Design Exception #19-07, 4681/2 and 470 251/2 Road Site Plan

Second Request at 4681/2 & 470 251/2 Road

468½ & 470 25½ ROAD SITE PLAN 468½ & 470 25½ Road, Grand Junction, CO

Exhibit C

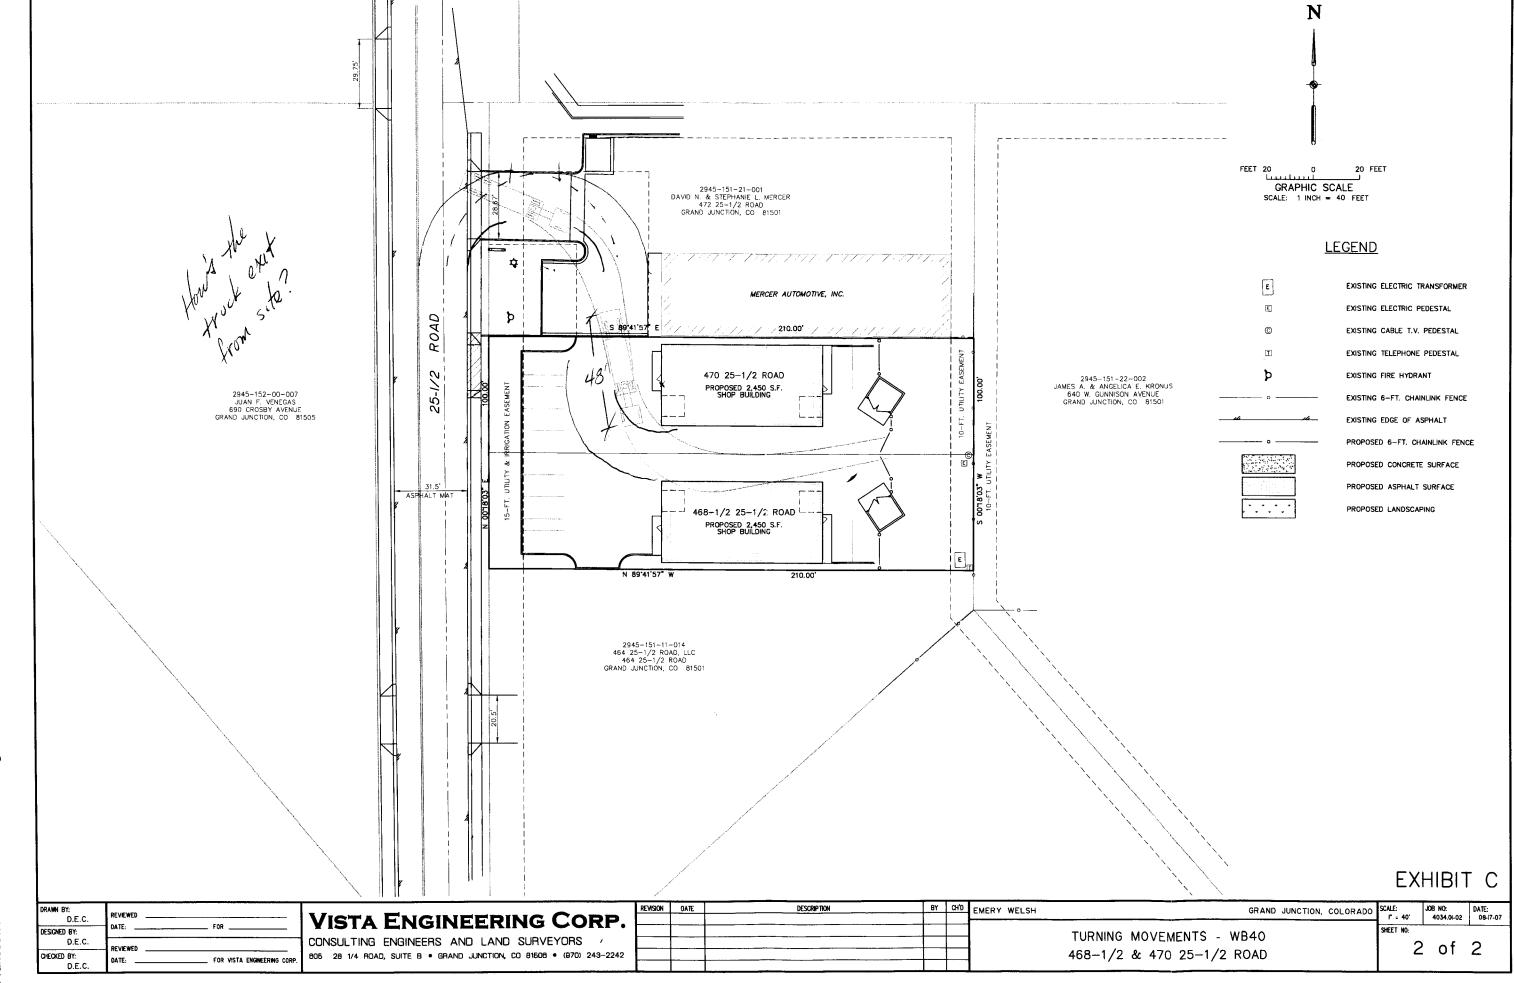
- 1. In the near future, the Crosby connection with Main Street is expected to be completed which will produce heavier traffic flow onto 25½ Road to and from the Rimrock Avenue shopping area.
- 2. 25½ Road is a Minor Collector and requires a 150' clearance between access points. The proposed driveway onto 25½ Road is only spaced 78' from the driveway to the north and 90' from the driveway to the south.
- 3. The applicant's engineer has indicated that to access his property from the existing "cross access" easement to the north (Mercer Automotives) would not allow a WB-40 truck to maneuver through the Mercer property. While this may be correct, I'm not sure if a WB-40 truck is necessary for the use of the subject property.

PROJECT NO. XXXX-FXXXX CONSTRUCTION NOTES H:\TurningMovement2.dwg, PLAN, 9/12/2007 3:40:20 PM, leec, Tabloid -MOVEMENT #1 100'-0" - 10'-0" -210'-0"-DESCRIPTION PUBLIC WORKS AND UTILITIES ENGINEERING DIVISION Grand Junction EXPECTED TURNING MOVEMENT FOR WB-40 TRUCKS CHECKED BY _ _ DATE .

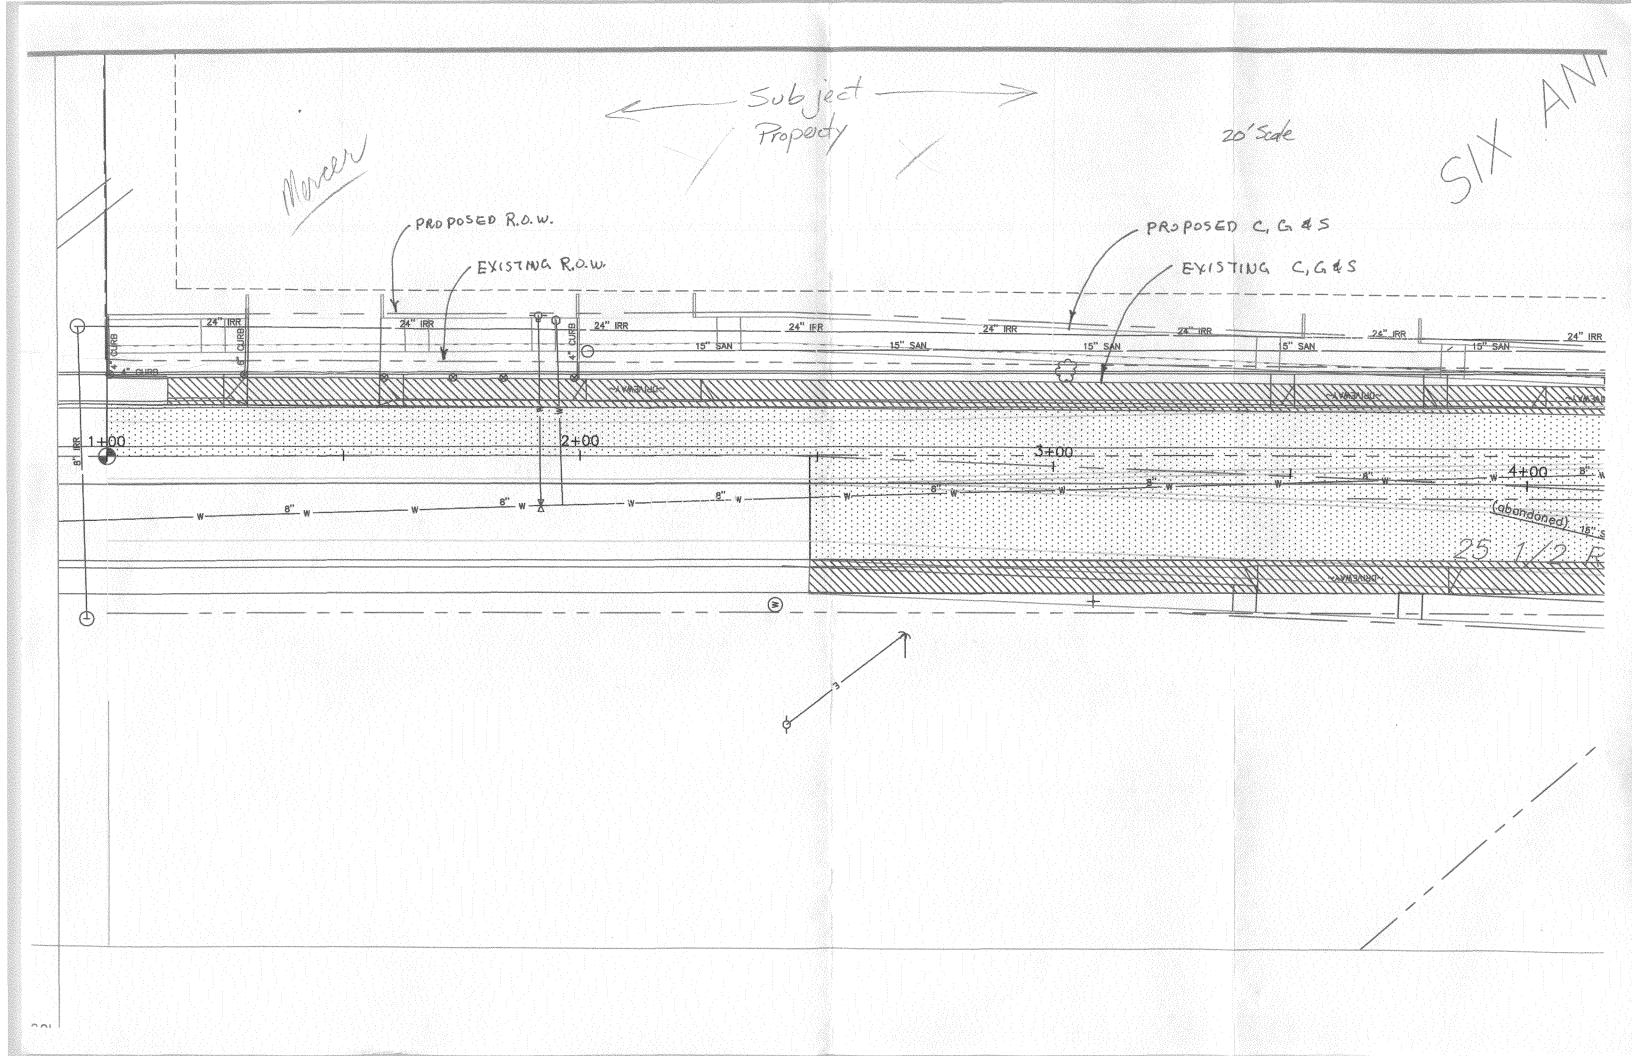
The TEDS Exception Request marginally demonstrates a WB-40 truck maneuvering around the rear of the site which would allow the truck to pull back onto 25½ Road.

With further efforts from the City's staff, the attached figures show that a driver would need to make five tight maneuvers to turn the truck around.
